# HISTORIC AND DESIGN REVIEW COMMISSION

**HDRC CASE NO:** 2019-609  
**COMMON NAME:** 105, 107, 109, 111 and 113 BROWN STREET  
**ADDRESS:** 415 N MESQUITE ST  
**LEGAL DESCRIPTION:** NCB 568 BLK 17 LOT E 70 FT OF N 27.5 FT OF 10  
**ZONING:** IDZ, H  
**CITY COUNCIL DIST.:** 2  
**DISTRICT:** Dignowity Hill Historic District  
**APPLICANT:** MICHAEL PEREZ/MP2 URBAN DEVELOPMENT LLC  
**OWNER:** MICHAEL PEREZ/MP2 URBAN DEVELOPMENT LLC  
**TYPE OF WORK:** Amendment to a previously approved design regarding windows  
**APPLICATION RECEIVED:** October 15, 2019  
**60-DAY REVIEW:** December 14, 2019  
**CASE MANAGER:** Edward Hall  
**REQUEST:**

The applicant is requesting a Certificate of Appropriateness for approval to amend the previously approved design regarding window materials. The applicant has proposed to install aluminum windows in lieu of the previously approved aluminum clad wood windows.

**3** TYP HEAD AND SILL, SIDING FINISH  
A7.00 SCALE 3" = 1'-0"

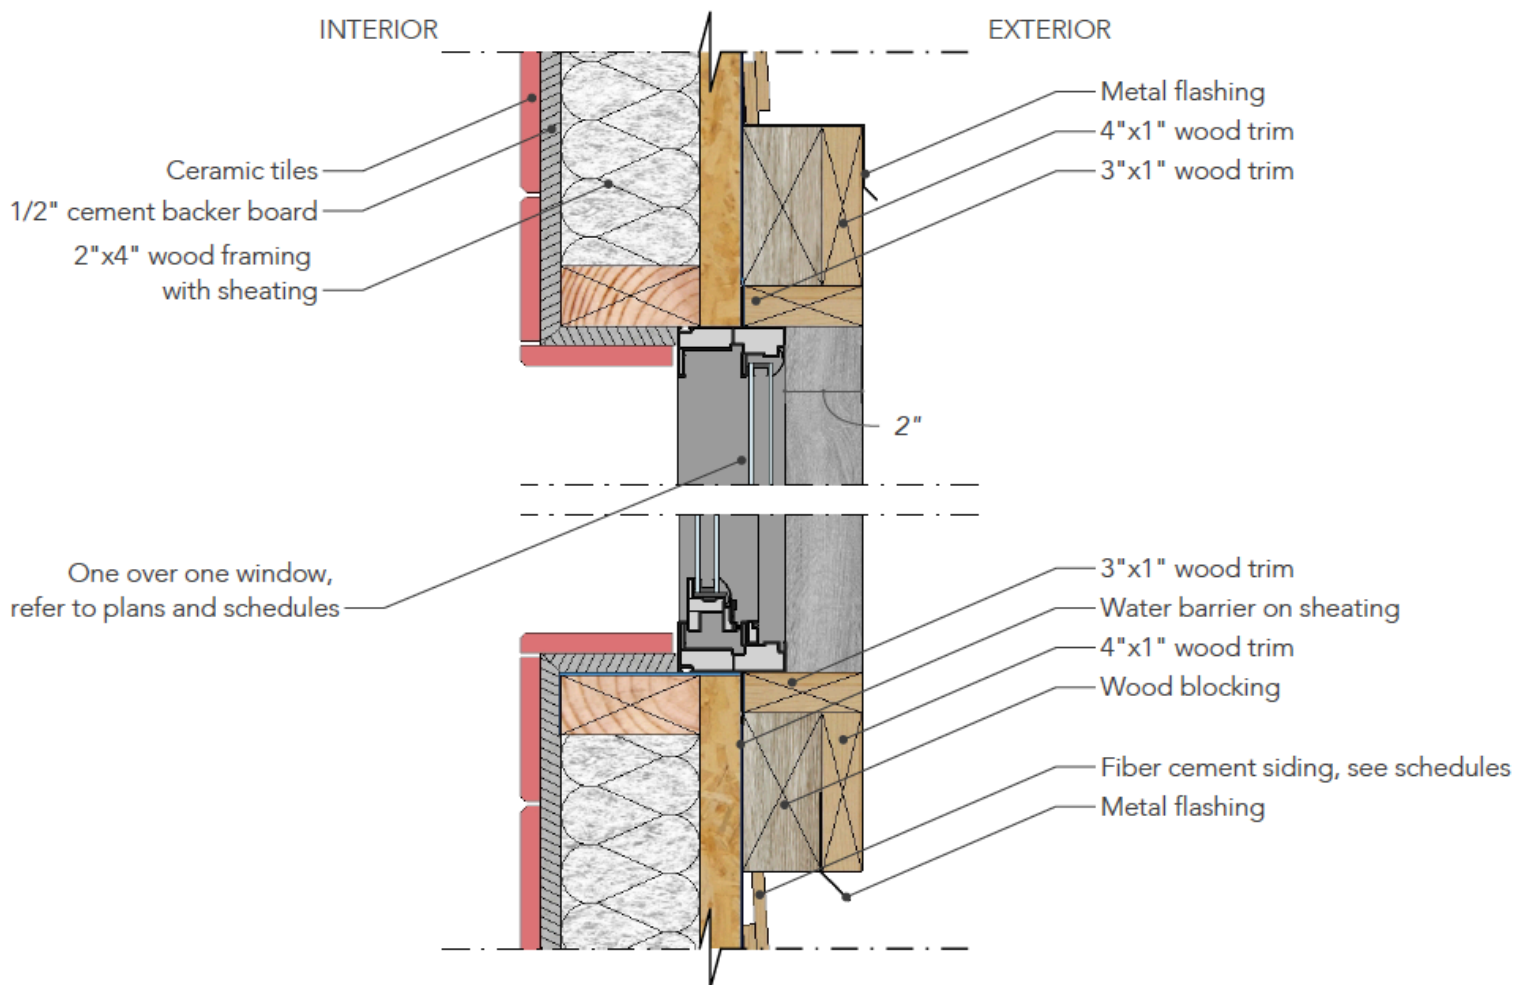
proposed windows with various wall assemblies, including composite siding, stucco and clay bricks. The applicant has noted a depth of three (3) inches between the top window sash and the face of the exterior cladding material (masonry); however, the detail for the installation within a wall assembly feature composite siding (Detail 3) features both a 2x4 and 1x4 to add thickness above the wall sheathing. Staff's specifications for windows note the following: *There should be a minimum of two inches in depth between the front face of the window trim and the front face of the top window sash. This must be accomplished by recessing the window sufficiently within the opening or with the installation of additional window trim to add thickness. Window trim must feature traditional dimensions and an architecturally appropriate sill detail.* Staff finds the applicant's proposed detail to add depth to the installation is atypical and that 2.25 inches in window trim is not found historically within the district.

- i. That the applicant revise detail 3 to feature a reduced amount of exterior trim while maintaining a two inch installation depth from the exterior wall plane. As currently proposed, the front face of the top window sash exceeds past the composite siding and is only recessed due to the combination of a 2x4 and a 1x4.
